# Intel<sup>®</sup> 80314 I/O Processor Companion Chip

## Specification Update

| *July 2005*

Order Number: 273759-010US

Figure 1. Power-Sequencing Requirements

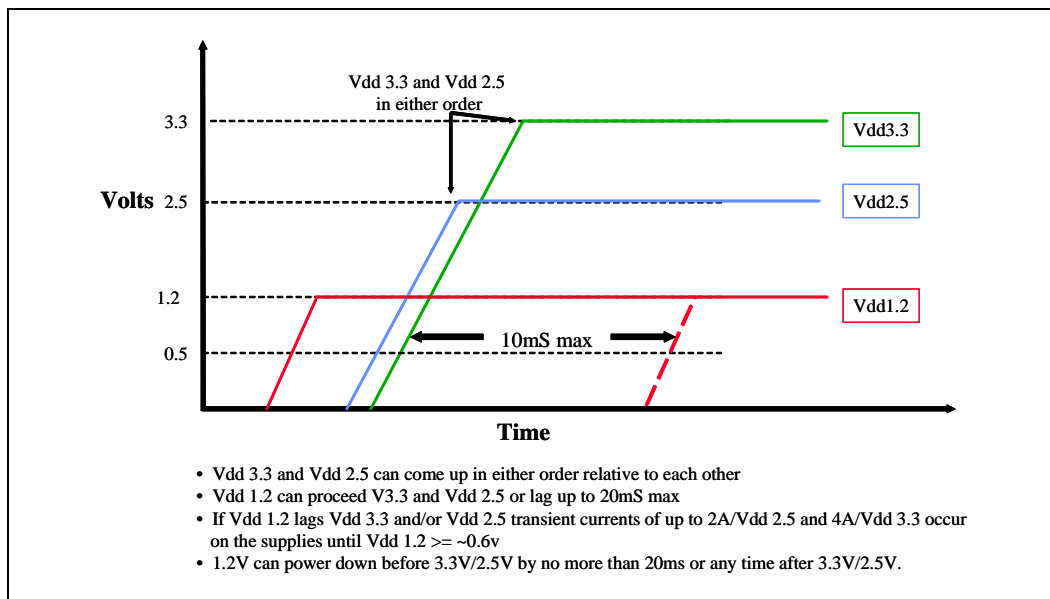
## 7. Power-sequencing requirement

Issue: The power-up and power-down sequences of the 80314 1.2 V/2.5 V/3.3 V supply rails has been revised from version 003 and 004 of this specification update. The power sequencing requirements initially presented in version 003 were designed to avoid transient current draw that could appear on the 2.5 V/3.3 V supply rails. Further investigation has determined that no current transients occur when the 1.2 V supply is ramped first. In addition, it is acceptable to ramp the 1.2 V supply after the 2.5 V and 3.3 V supplies as long as the lag is less than or equal to 20 mS. When the 1.2 V rail lags the 2.5 V and/or 3.3 V rail, transient currents of up to 2 A/V<sub>DD2.5</sub> and 4 A/V<sub>DD3.3</sub> can occur on the supplies until V<sub>DD1.2</sub> >= ~0.6 V. The 1.2 V supply can power down no more than 20 ms before or any time after the 3.3 V/2.5 V supplies power down. These requirements are illustrated in Figure 1.

Affected Docs: *Intel® 80314 I/O Processor Companion Chip Design Guide* (Section 11.1)  
*Intel® 80314 I/O Processor Companion Chip Datasheet*
